**POTENTIAL EXPLORATION, DEVELOPMENT, AND PRODUCTION OF
OIL AND GAS RESOURCES; VANDENBERG AIR FORCE BASE, CALIFORNIA**

FINAL ENVIRONMENTAL IMPACT STATEMENT

The final EIS relies upon the analyses provided in the draft EIS. It does not repeat draft EIS information. It provides erratas for the EIS, Air Quality Technical Appendix, and MRMP. In addition, public and written comments on the draft EIS and responses are provided.

Figure 6.5-10

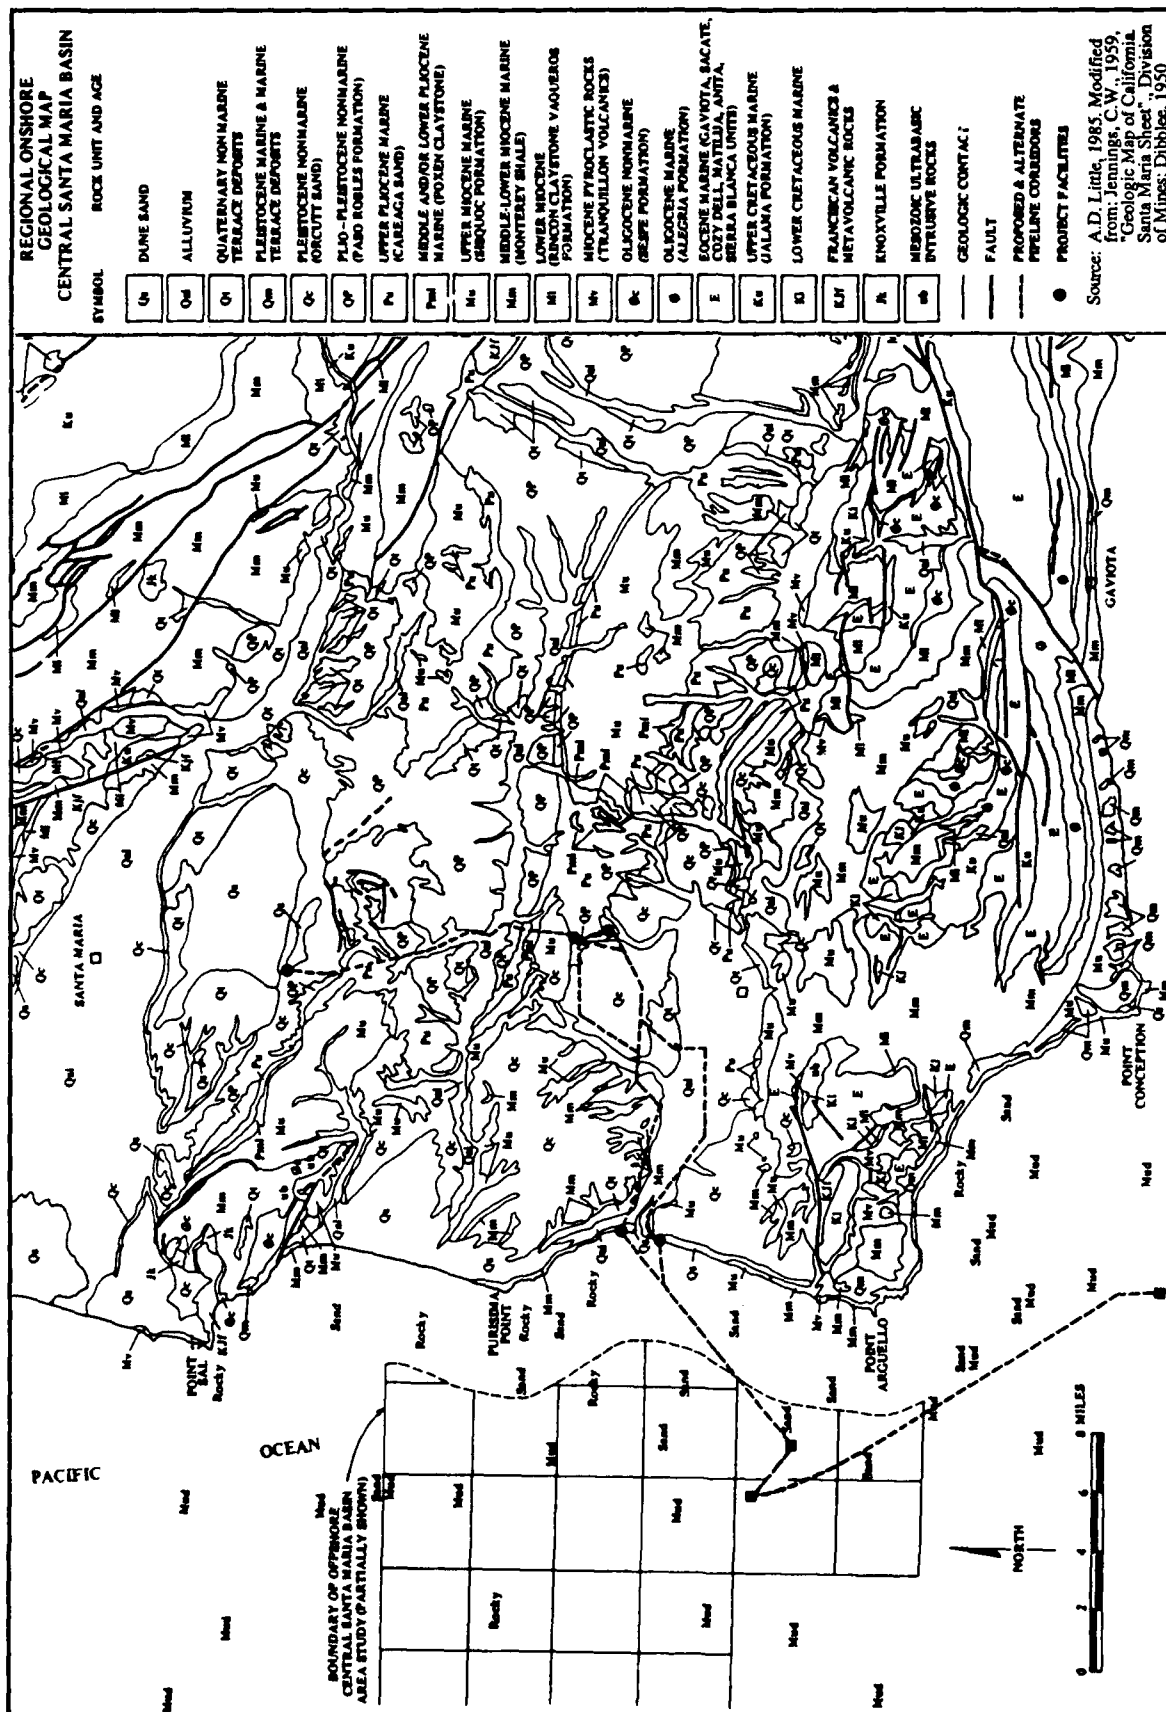
More detailed information about the potential of various formations for containing vertebrate fossils and the distribution of the formations can be found in Table 6.5-4 and in Figure 6.5-10 (see the attached table and figure). Note that in Figure 6.5-10, the map unit Qm includes both marine and continental terrace deposits that are symbolized by QT₁, QT₂, and QT₃ in Table 6.5-4.

Figure 7-2
COMPOSITE ENVIRONMENTAL HIGH-CONSTRAINT AREAS

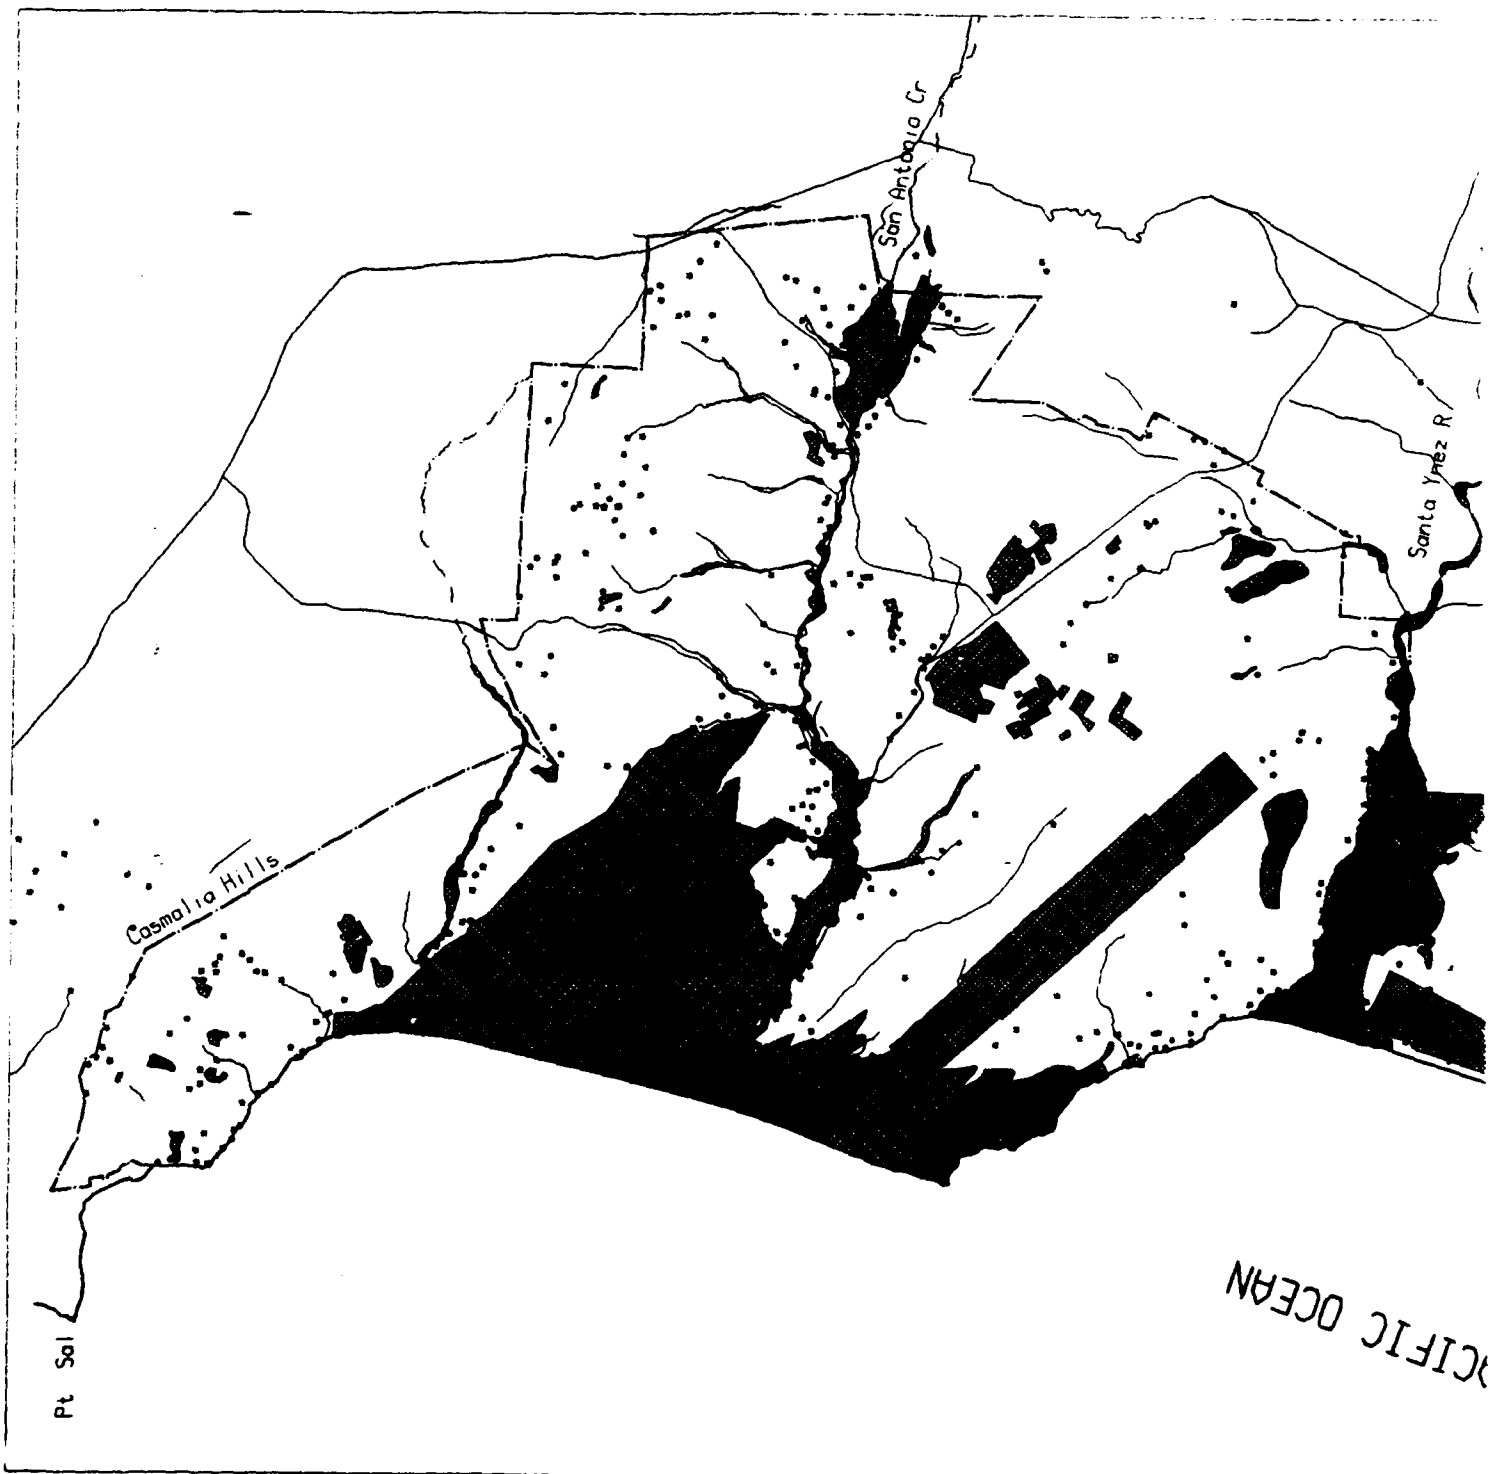
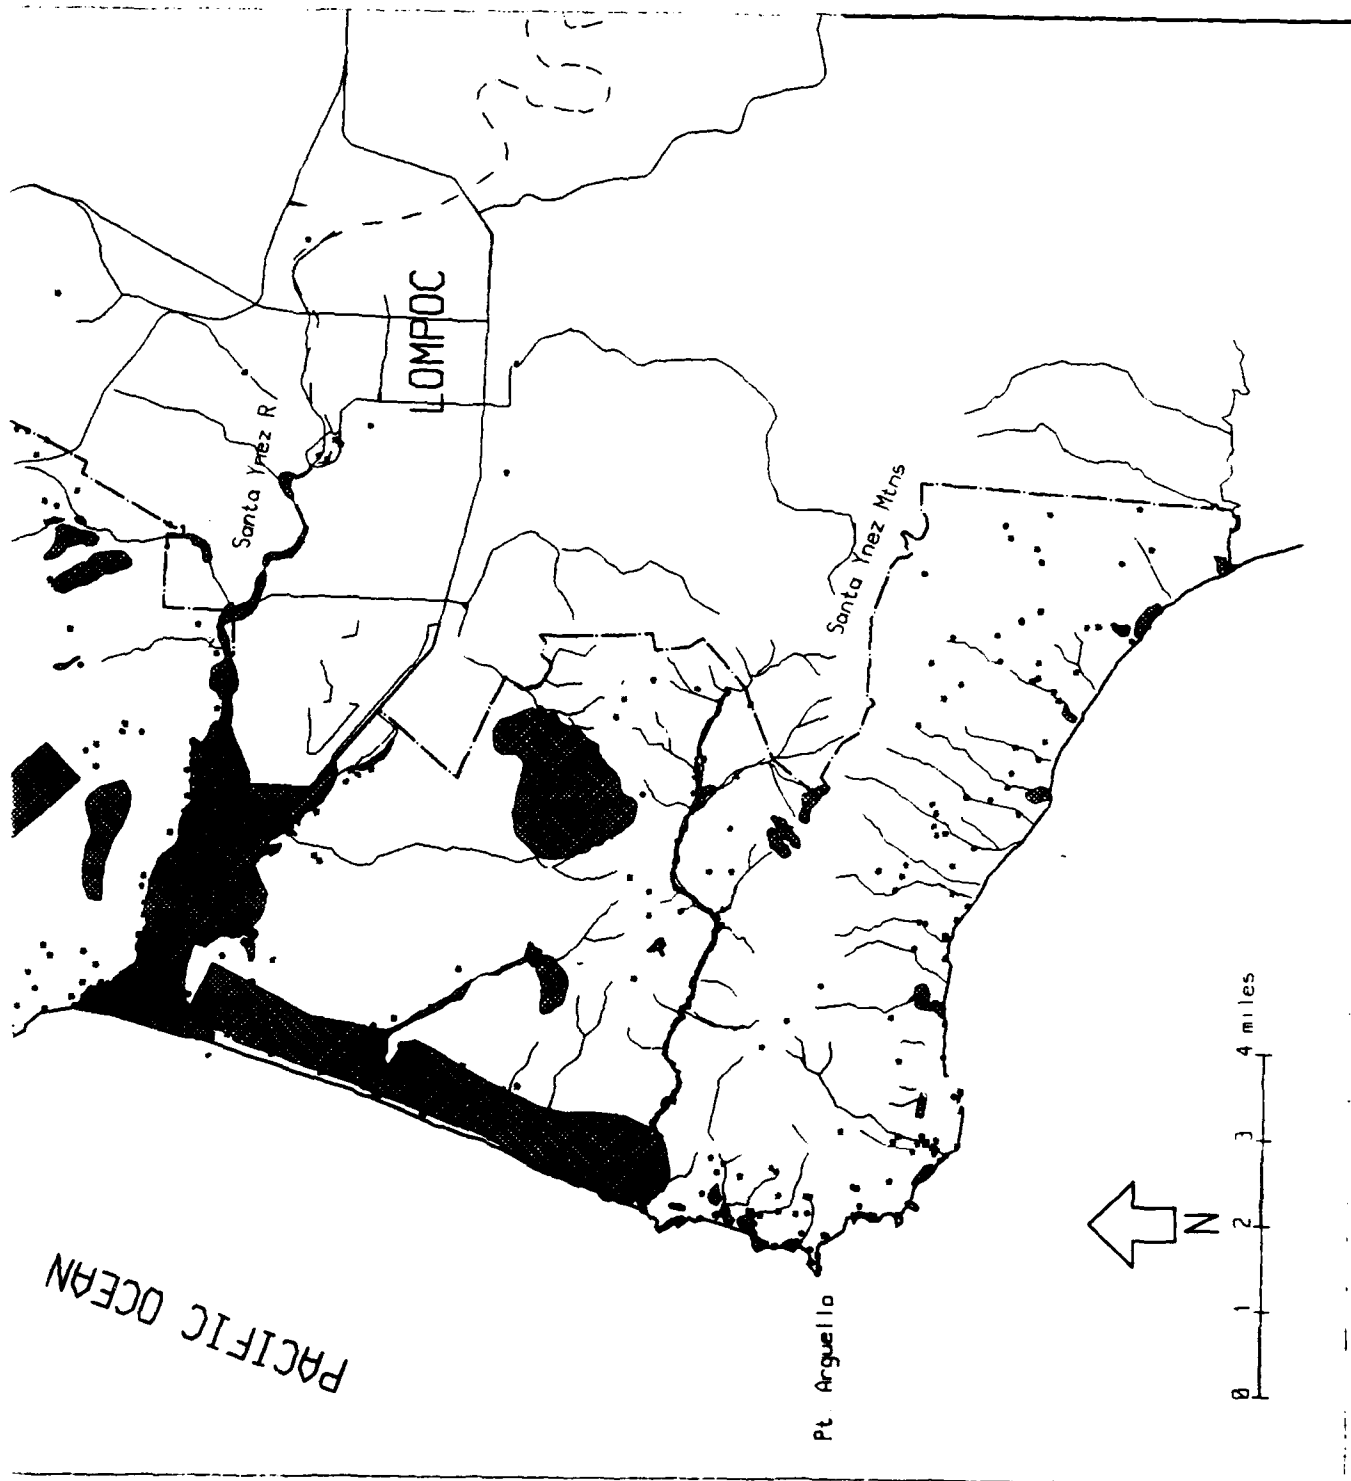
18. Figure 7.2, page 7-7. The LEGEND block is empty; either Legend text must be added, or the block must be removed. Also, this figure should include all lands within the Lompoc and San Antonio Groundwater Basins, since overdrafted groundwater resources are acknowledged in the text as a "high environmental constraint (see e.g. Sec. 6.2.4.1, p. 6.2-21, middle of first full paragraph; Sec. 7.3.3.2, p. 7-6).

A legend is unnecessary for Figure 7-2, Composite Environmental High-Constraint Areas, on page 7-7; therefore, the legend inset has been removed. See attached figure.

- RMD-131 See the response to comment SLC-1.
- RMD-132 The legend is unnecessary and has been deleted from Figure 7-2. Please see the MRMP errata for section 7.0, Plan Criteria and Application. The referenced map gives information on locations of oil and gas facilities which may be constrained by water resource attributes. As noted in the response to comment RMD-83, the location of oil field development is not geographically tied to the location of the water source which would supply the facility. The purpose of this figure is to provide geographic information on constraints of oil and gas development on base.
